From: Bekta, Eugene D - DNR <Eugene.Bekta@wisconsin.gov>
Sent: Wednesday, June 3, 2020 3:31 PM
To: Tim Brown
Subject: RE: Construction Site Storm Water Discharge Permit Coverage

DNR has issued construction site **Storm Water Permit Coverage** for **Red Hawk Apartments, City of Milton, WDNR FIN 68831**. The coverage is effective today, **October 23, 2019**.

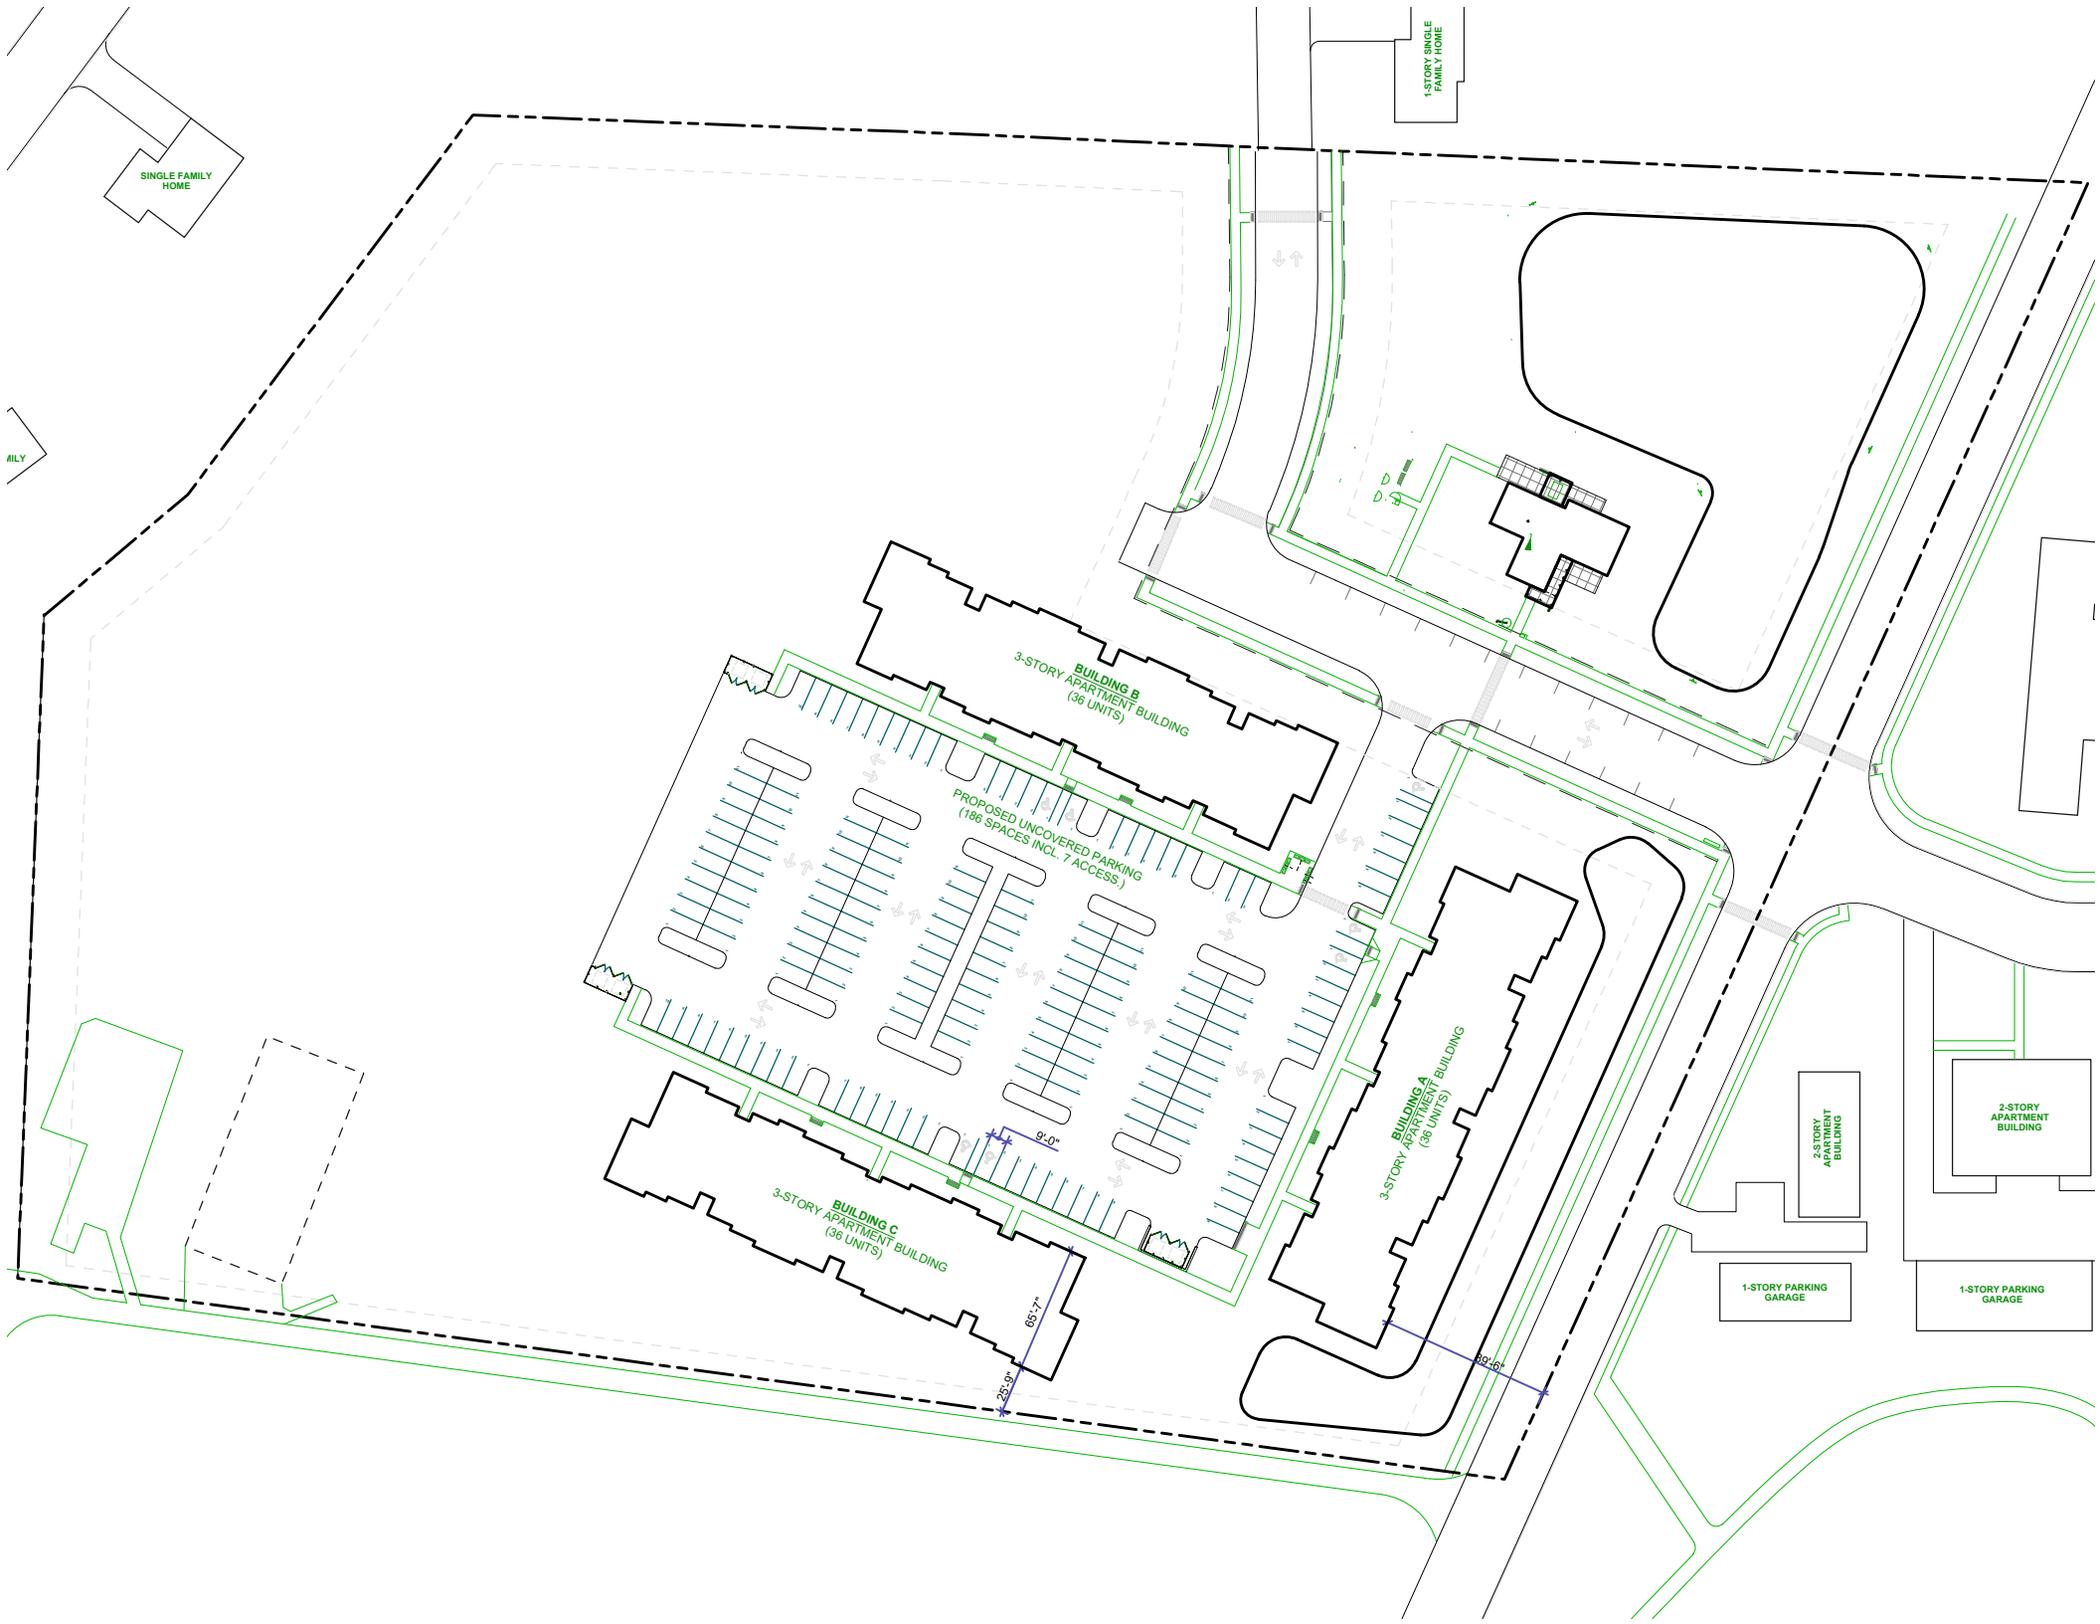
Attached are two rough sketches, the permitted file is the one that you have seen and approved. The new file is the potential redesign without the garages. Would these need to be fully re-permitted?

We received a request from the owner of the project to remove the garages in the parking lot. I want to reach out to you to see if you would need to rereview the project or if this could be handled as a field change. If anything, this change will result in more pervious area (removing garage roofs and installing landscaped islands) with less underground pipe. Please feel free to call me to discuss.

This work can be included under the current DNR storm water permit. However, as City of Milton is a permitted MS4, DNR defers to the city for any additional storm water requirements.
